This document transmits the Initial Issue of Service Bulletin EV2500-72-0469 and the Initial Issue of the Supplement

ENGINE – LP COMPRESSOR TO ANNOUNCE THE AVAILABILITY OF LPC FRONT CASE WITH HIGHER
EROSION RESISTANT ABRADABLE SEAL

V2500-ENG-72-0469

Location of Case A/O Front LPC
Figure 3 sheet 1

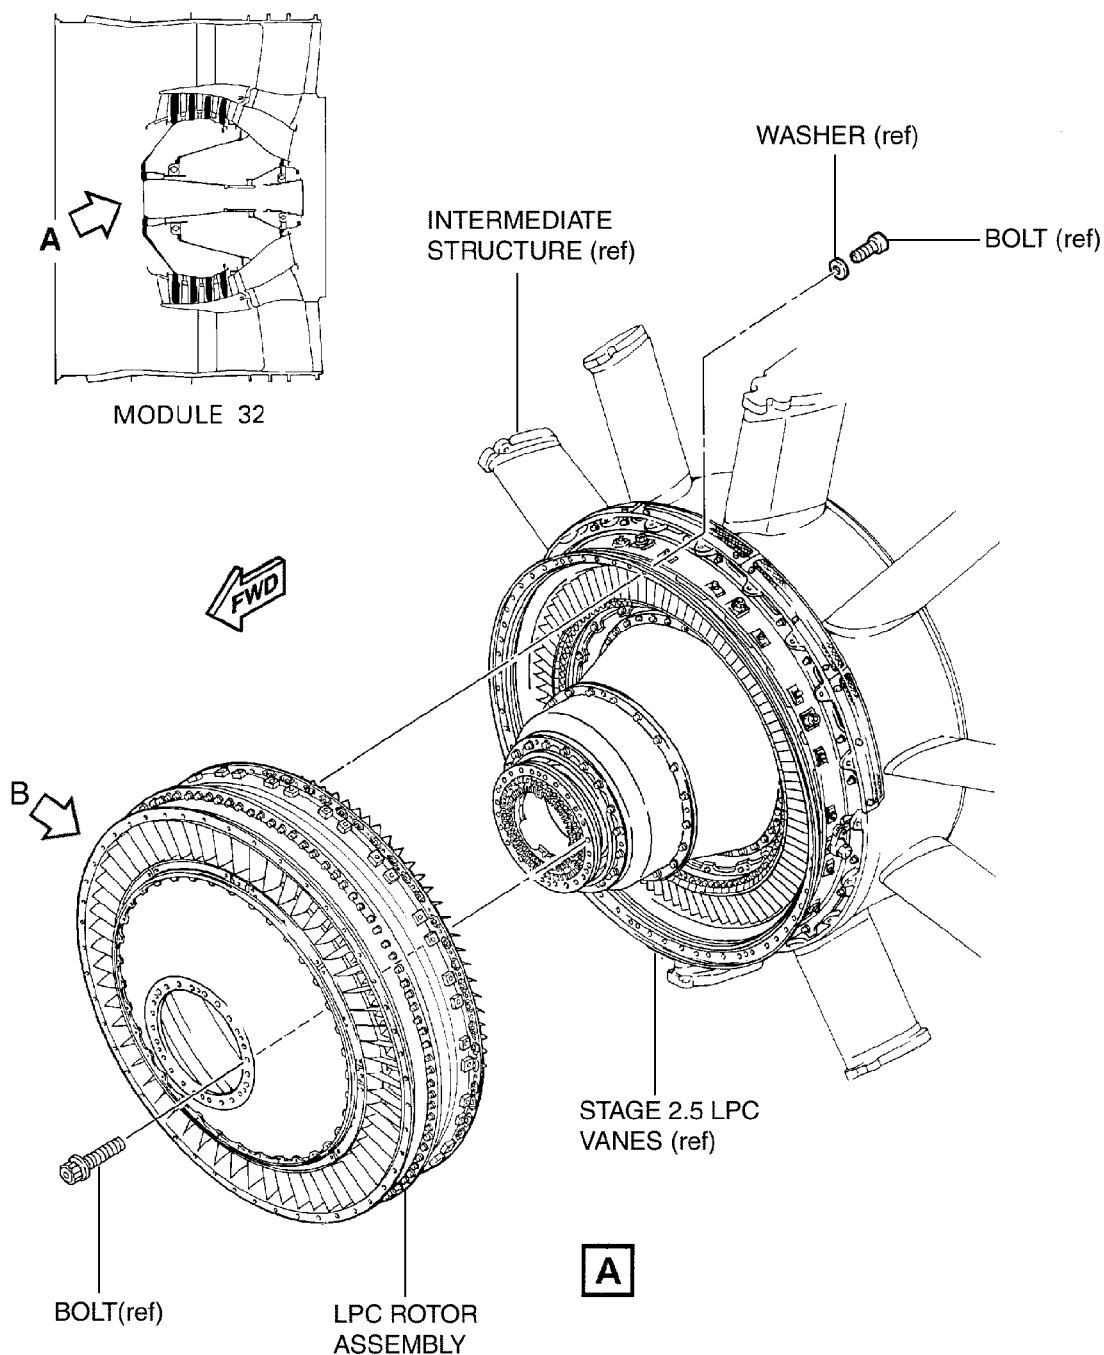
Refer to figure 3 sheet 1 and sheet 2
and figure 4 sheet 1.

Replace the abradable seal of the LPC front case
Figure 4 sheet 1

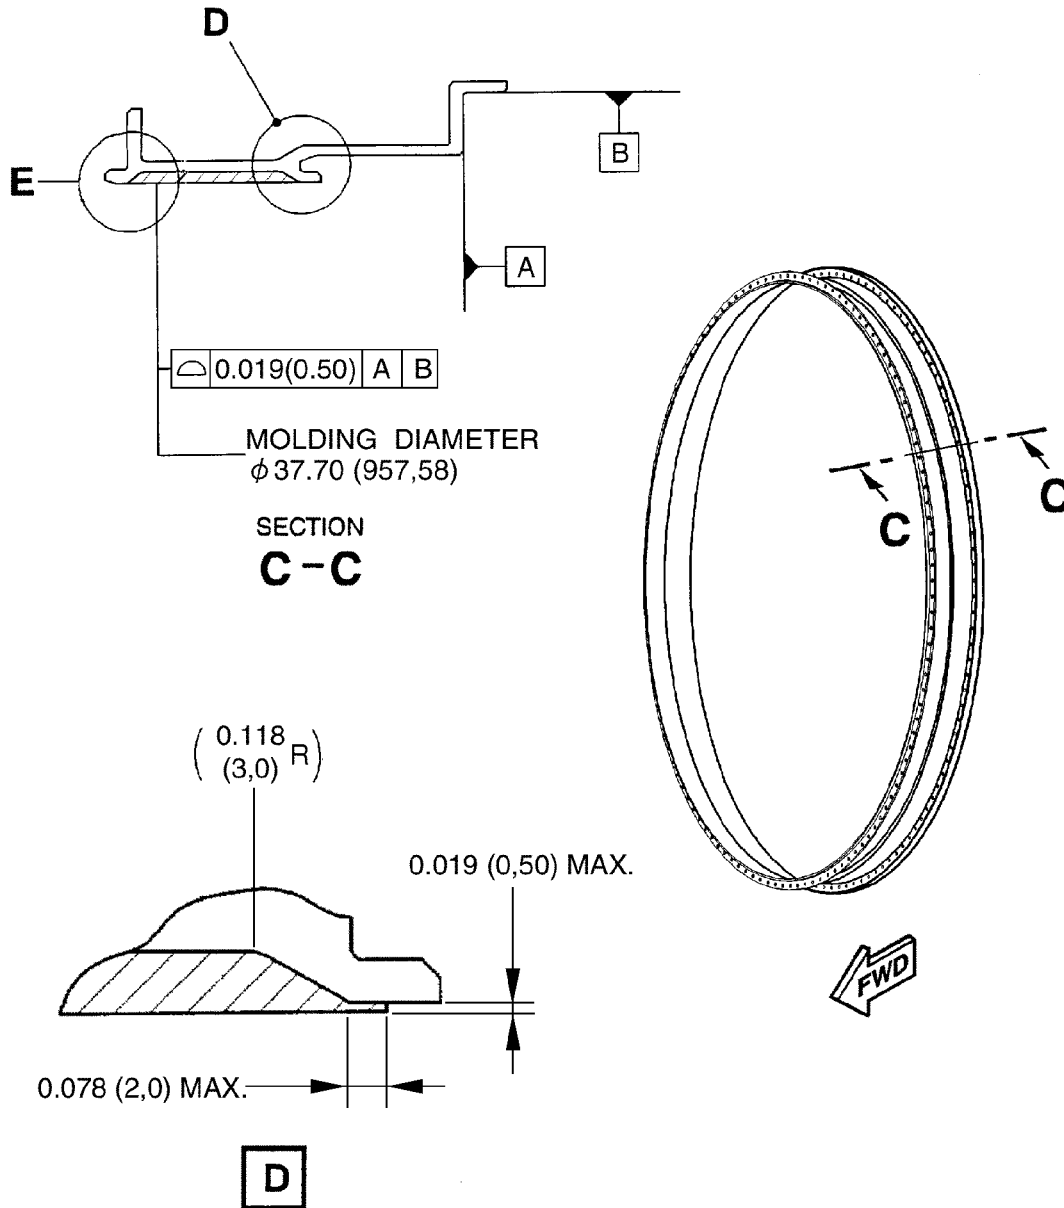
- (b) Do a dimensional inspection of the molding diameter of abradable seal. If necessary, grind the diameter of the abradable seal
- Refer to figure 4 sheet 1

Replace the abradable seal of the LPC front case
Figure 4 sheet 2

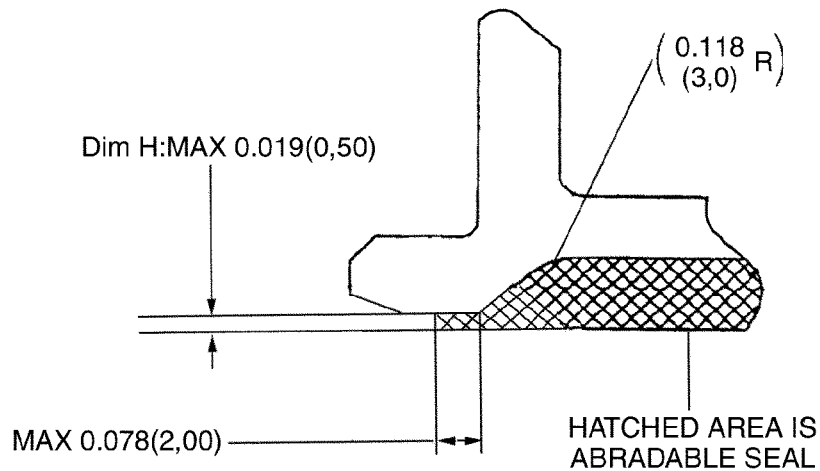
- (c) Do a dimensional check of excess abradable seal (Dim. H.). If necessary, remove the excess resin by using grinding equipment, cutter/knife and/or equivalent

- Refer to figure 4 sheet 1 and sheet 2
If Dim. H. the height between the front liner surface of LPC front case and inner surface of abradable seal, is more than 0.019in. (0,50 mm), blend abradable seal Refer to figure 4 sheet 3

Replace the abradable seal of the LPC front case
 Figure 4 sheet 4

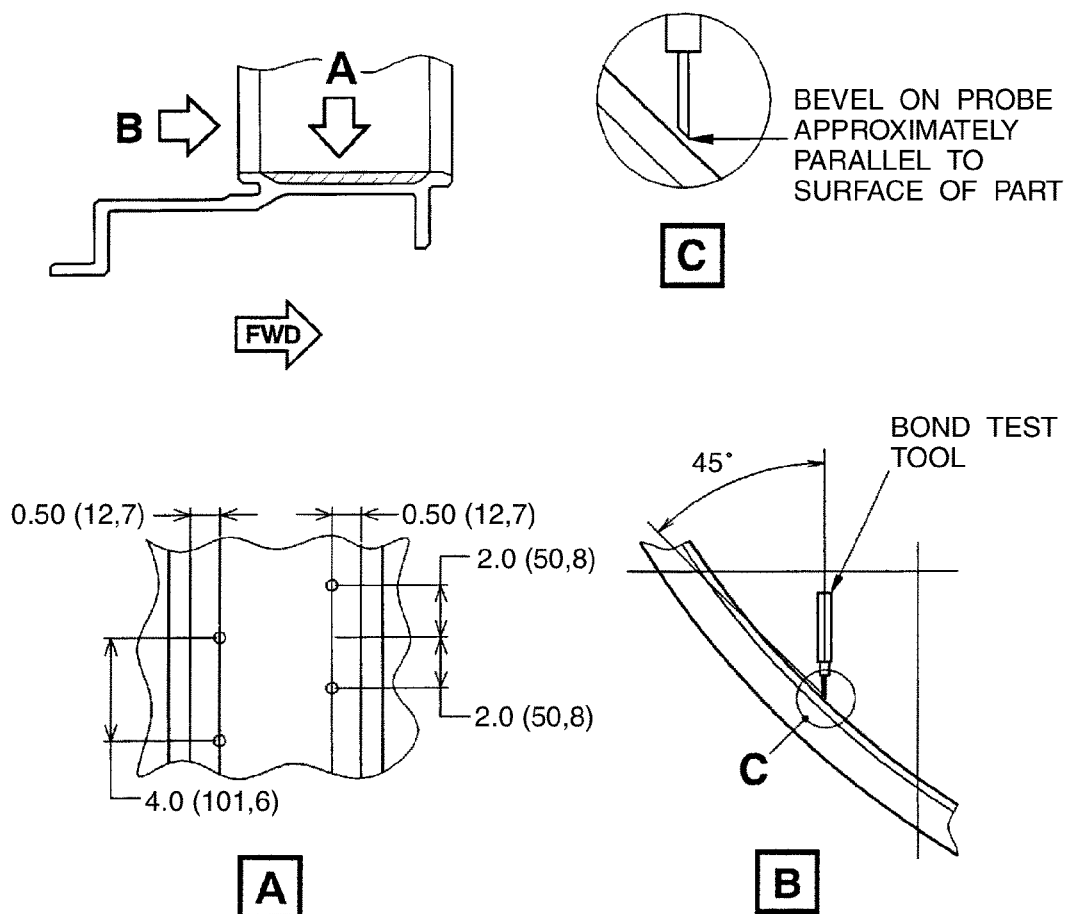
- (10) Examine the repaired area
- (a) Visually examine the repaired area
- Voids: Refer to figure 4 sheet 4
Recesses: Refer to figure 4 sheet 4
Discoloration: Refer to figure 4 sheet 4
Cracks are not permitted
Foreign inclusion is not permitted
Peelings are not permitted
Bubbles are not permitted

Do a bond test of the required area of the LPC front case assembly
Figure 5

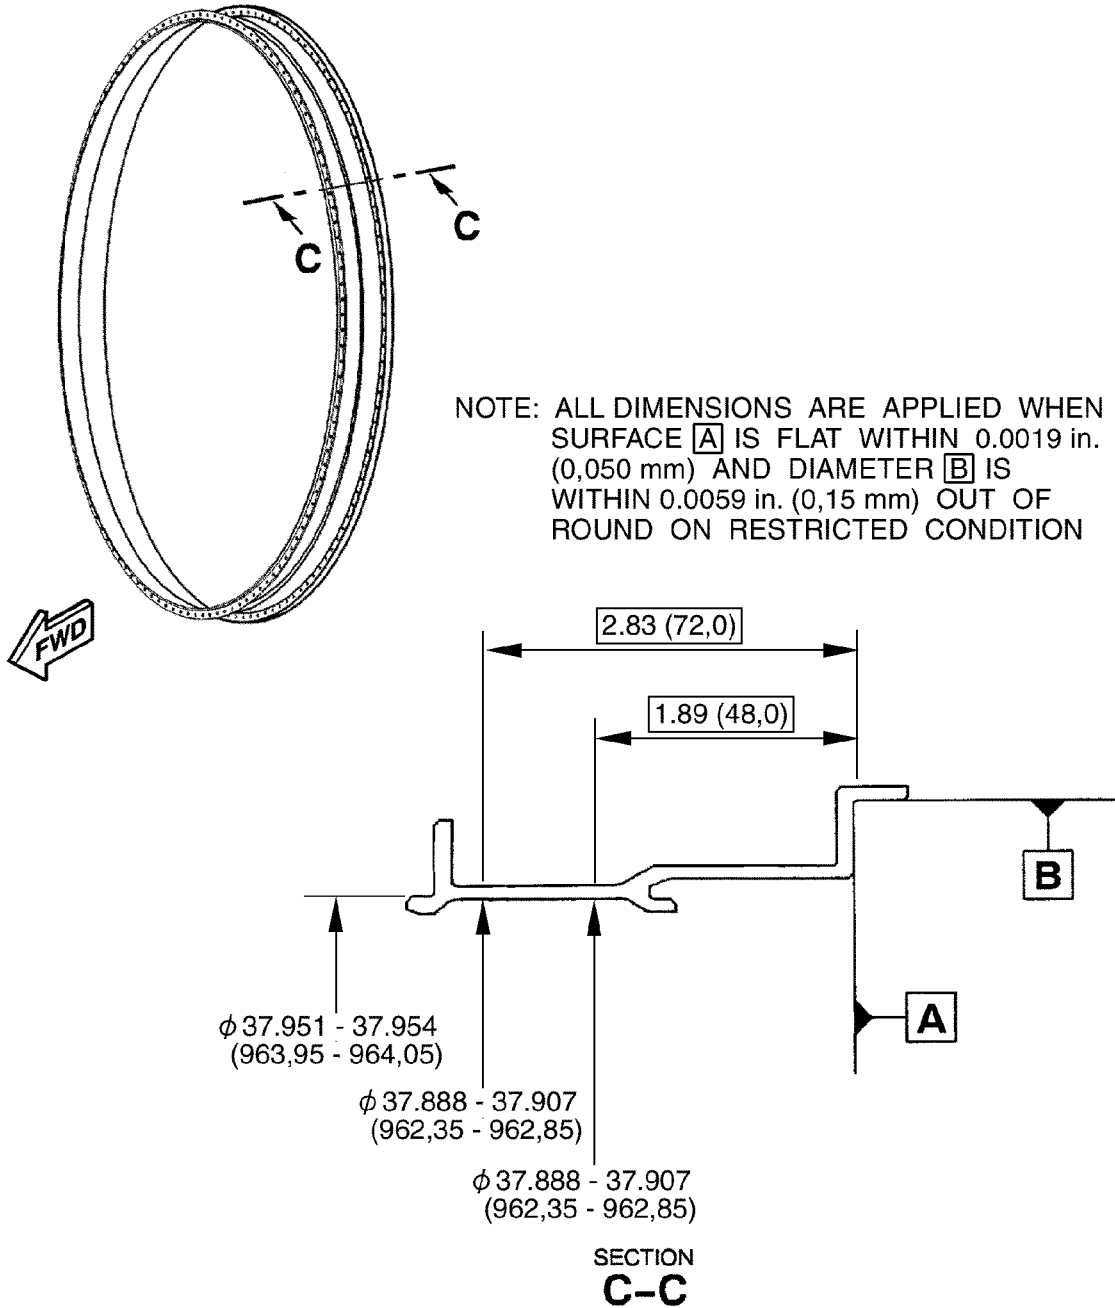
(a) Do a bond test of the repaired area | Refer to figure 5 Use IAE 3J12775 bond test fixture 1 off, IAE 3J12785 inspection stand 1 off and IAE 3J12792 inspection stand 1 off No signs of bulging or air leakage are permitted |

Inspection gas: Air or nitrogen gas Gas pressure: 200 psig (1380 kPa) Inspection position: Change the pattern as necessary to examine the incomplete repaired areas Probe angle: Approximately 45 degrees.

Dimension required after water blast cleaning
Figure 6

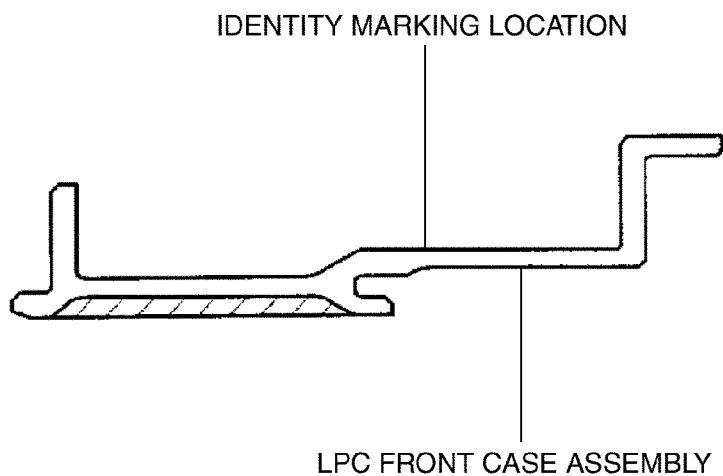
- (a) Remove the abradable seal Use a water blast jet Refer to SPPM TASK 70-15-01-160-501 Make test piece of AMS4132
- (b) Do a dimensional inspection Refer to figure 6 Use IAE3J12792 inspection stand 1 off if necessary
- (4) Examine the surface from which the abradable seal is removed. Refer to figure 4 sheet 1
- (a) Fluorescent penetrant examine the surface where abradable seal is removed Refer to SPPM TASK 70-23-05-230-501 Use CoMat 06-064 fluorescent penetrant
- (5) Apply surface protection to the LPC Front Case Assembly Refer to figure 4 sheet 1
